Access Compliance Report

Public Rights-of-Way

(Curb Ramps)

Intersection ID: 18906	Main Street: GLEN LYON DR	Cross Street: MARGARET WALLACE RD	Location: NW
ADA ID: 21A0CACE2CC7	Ramp Type: PerpDiag	Initial Pass/Fail: Fail	Overall Compliance: No
Severity Score: 25			
Codes/Mitigation Info/Possible Solution		Field Measurements/Component Compliance

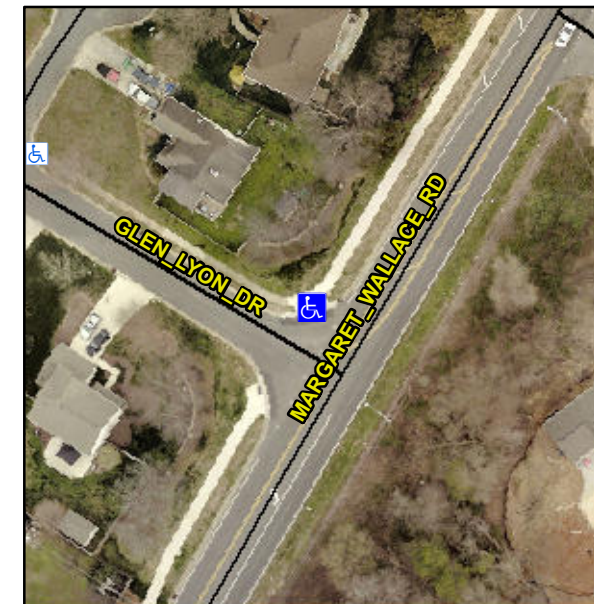
R304.2.2, R304.5.3

Compliance	Description	Data	Compliance	Description	Data
N/A	Ramp Length (in)	54.0	No	Ramp Slope (%)	8.4
Yes	Ramp Width (in)	48.0	No	Ramp XSlope (%)	5.4
N/A	Flare Type LT	N/A	N/A	Flare Type RT	N/A
N/A	Flare Slope LT (%)	N/A	N/A	Flare Slope RT (%)	N/A
N/A	Flare Traversable LT?	N/A	N/A	Flare Traversable RT?	N/A
N/A	Landing Length (in)	N/A	N/A	DWS Provided?	N/A
N/A	Landing Width (in)	N/A	N/A	DWS Contrast?	N/A
N/A	Landing Slope (%)	N/A	N/A	DWS Length (in)	N/A
N/A	Landing X Slope (%)	N/A	N/A	DWS Full Width?	N/A
N/A	Landing Curb? (Y/N)	N/A	N/A	DWS Offset (in)	N/A
N/A	Shared Landing?	N/A			
N/A	Gutter Ponding?	N/A	N/A	Gutter Slope (%)	N/A
N/A	Gutter Lip Ht (in)	N/A	N/A	Gutter X Slope (%)	N/A
N/A	Painted X Walk1?	No	N/A	Painted X Walk2?	No
	X Walk 1 Direction	To SW		X Walk 2 Direction	To SE
N/A	X Walk 1 Width (in)	N/A	N/A	X Walk 2 Width (in)	N/A
	X Walk 1 Slope (%)	0.5		X Walk 2 Slope (%)	5.2
	X Walk 1 X Slope (%)	2.9		X Walk 2 X Slope (%)	3.3

Remove & Replace Curb Ramp With Two New Directional Ramps or Equivalent.
